MONTGOMERY COUNTY PLANNING DEPARTMENT
THE MARYLAND-NATIONAL CAPITAL PARK AND PLANNING COMMISSION

Local Map Amendment H-131 Kingsview Station

Local Map Amendment H-131: Kingsview Station

Figure 4. Proposed Floating Zone Plan

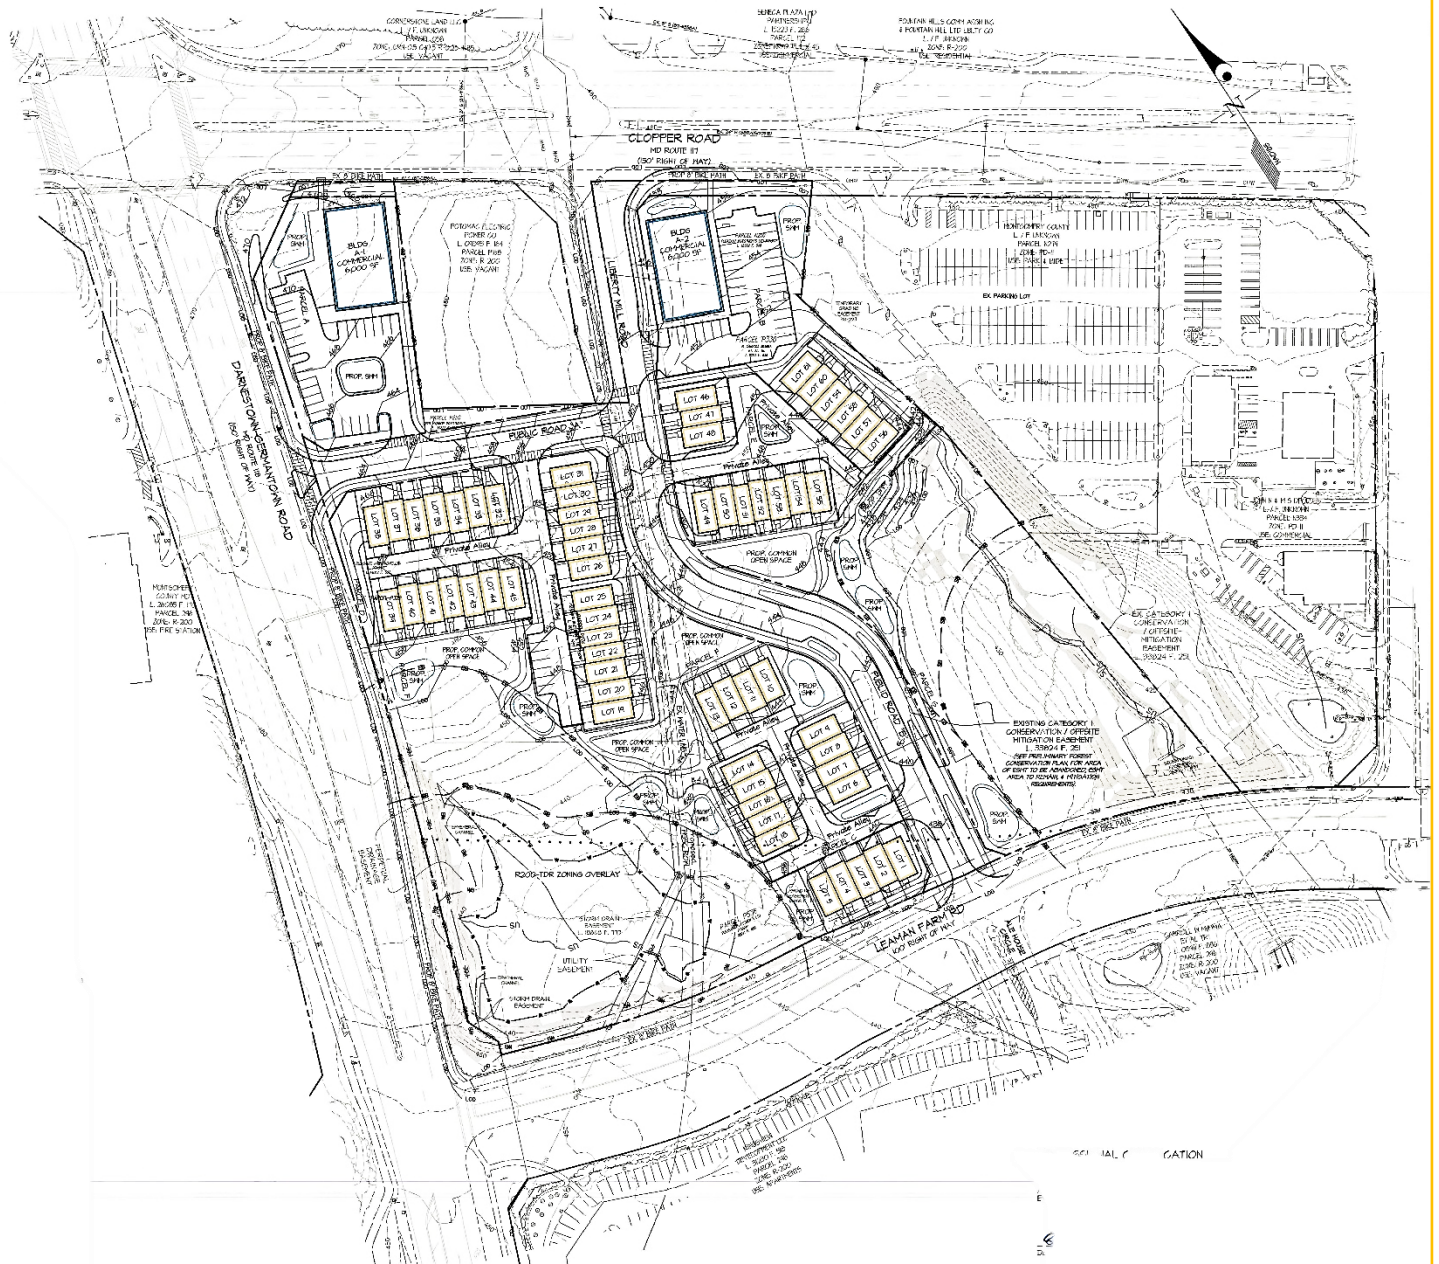
The issue of the electric transmission lines traversing the Property from north to south should be addressed for potential esthetic and safety impacts on the development and in particular, on the dwellings that would be in close proximity to the power lines.

Staff has concerns regarding the notable presence of a row of telephone poles with several electric transmission lines traversing the Property from north to south along the center of the Property. The impact of the transmission lines in terms of design and safety, should be analyzed in more detail as the Floating Zone Plans progresses to the next levels of reviews. The Applicant was not receptive to Staff's recommendation to underground the transmission line sighting the high cost of such undertaking with the potential to derail the feasibility of the proposed project.

Figure 5: Site Circulation

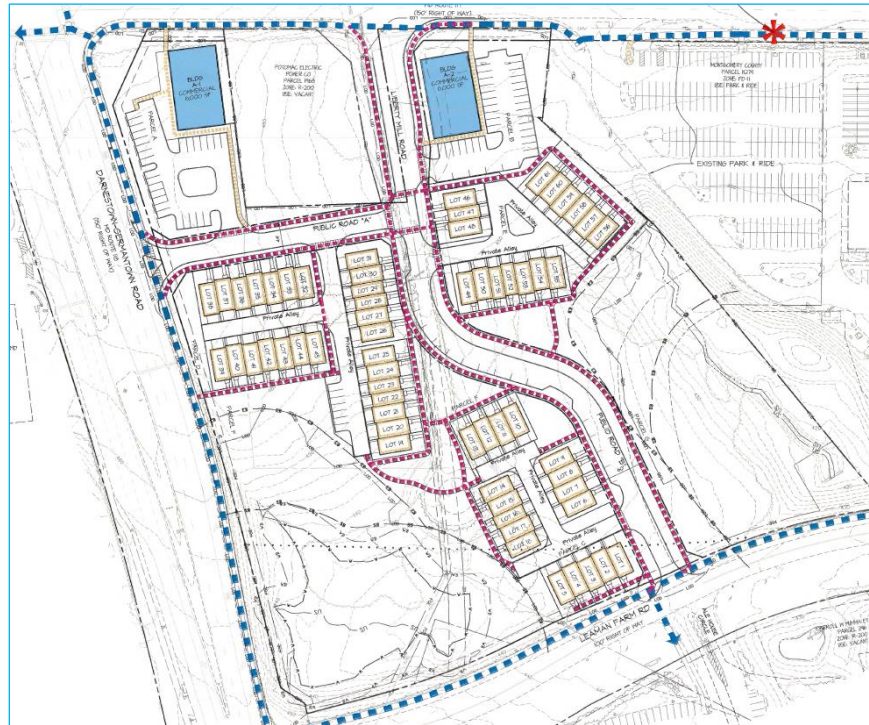
The Subject Property is adjacent to the MCDOT Kingsview Park and Ride facility, serviced by the 61, 71, 74, 78, and 98 Ride-On routes. Staff will work with the applicant to provide improved pedestrian connectivity from the Subject Property to this facility as well as to the Kingsview Village local retail center as part of the subsequent Preliminary Plan Review.

The 2018 Bicycle Master Plan recommends a shared use side-path to run along the south side of Clopper Road (MD 117) and along the east side of Germantown Road (MD 118). Final designs of these paths will be determined as part of subsequent development applications. A shared use path currently exists on Leaman Farm Rd.

The proposed access to the site, as shown on the Floating Zone Plan, to be adequate to serve the traffic generated by the development. Staff supports the transportation elements of the application.
